# GENERAL AND REVENUE SECRETARIAT

## File No. 58

Construction of a pond at Malimapura in Kelaniyangala &c

Final Estimate of the Probable Cost of Sinking a well at Thekal Reservoir

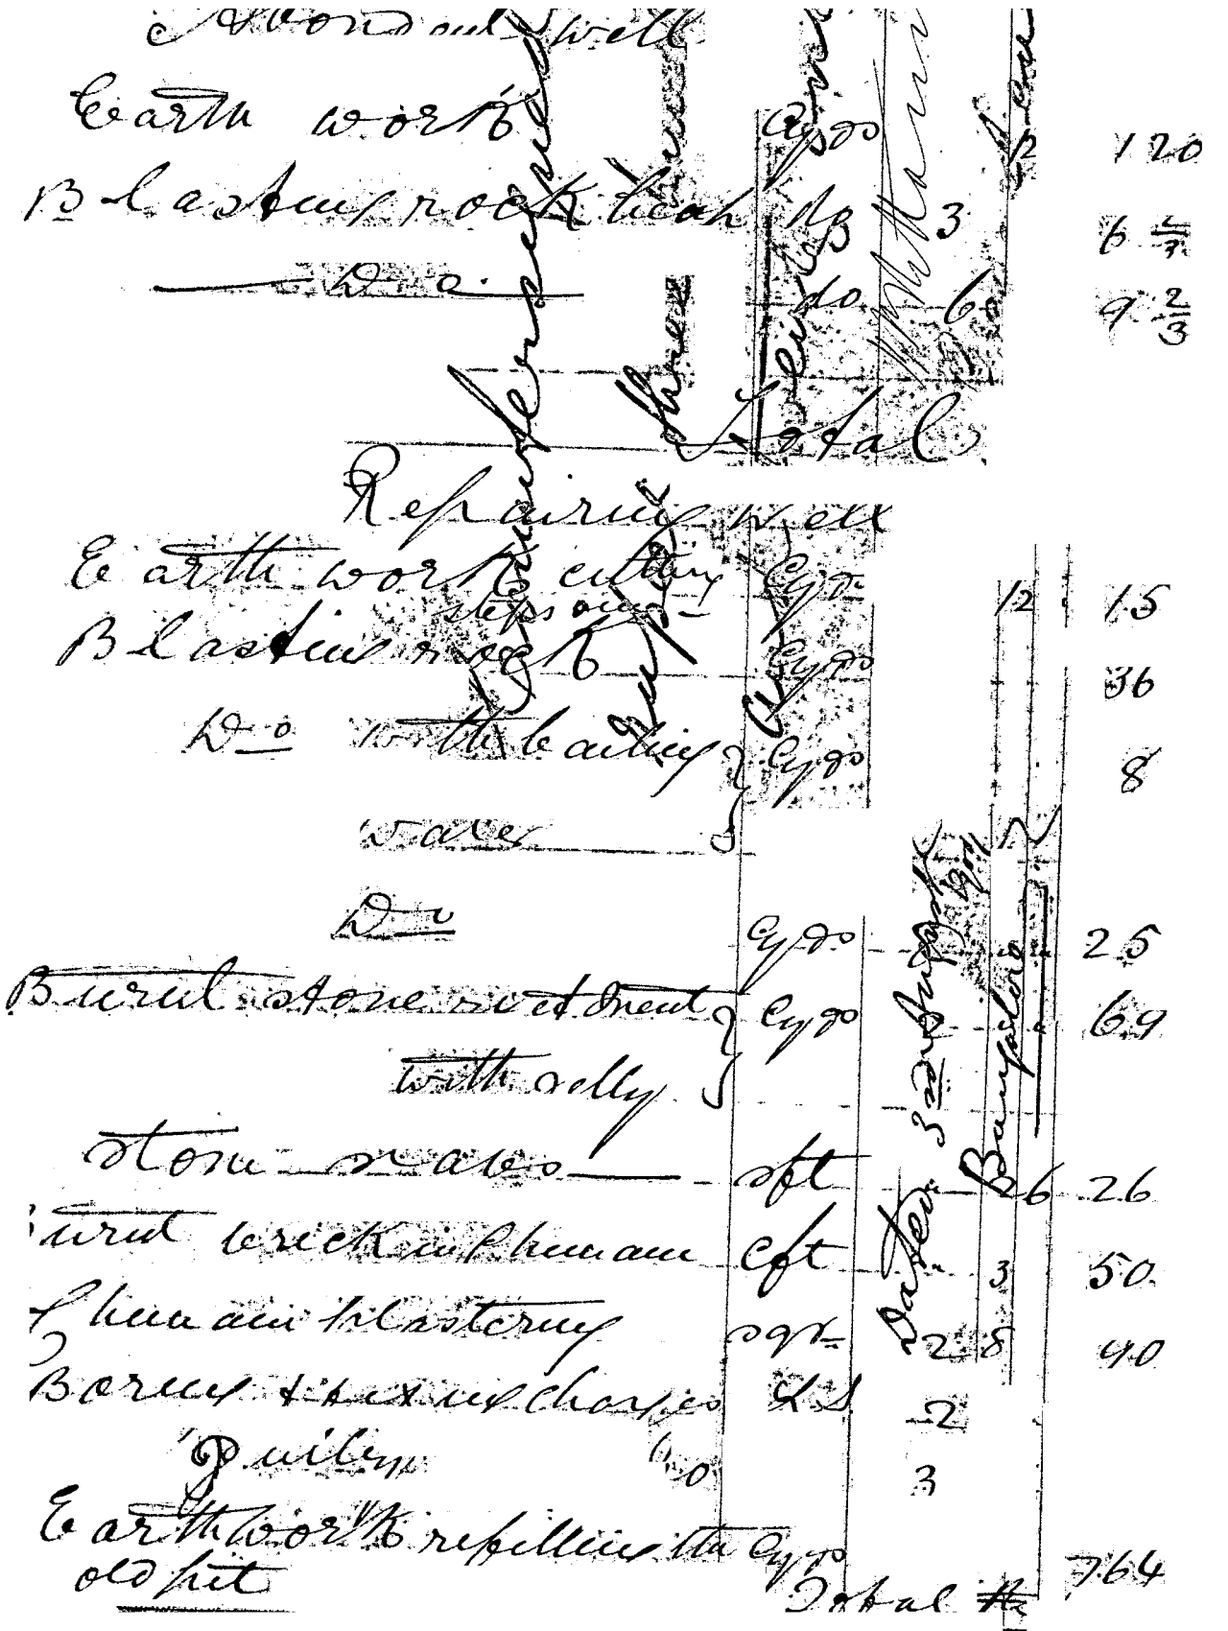
Who prepared this estimate?

as it examined by any P.W. Offr

(3) It involves a large amount it is one which had been once given up. I think the opinion of the Engrs ought to be obtained and recorded

Submitted by the President
lent does not appear to have
been examined by a P.W. officer
the total estimate of Rs 944,
a sum of Rs 168 represents
the amount paid to the
Contractor for sinking the
well, which has been
abandoned. The present
estimate is not for the old
well lent for deepening the old
pond, which had been
dug up by Patel Bainegowda
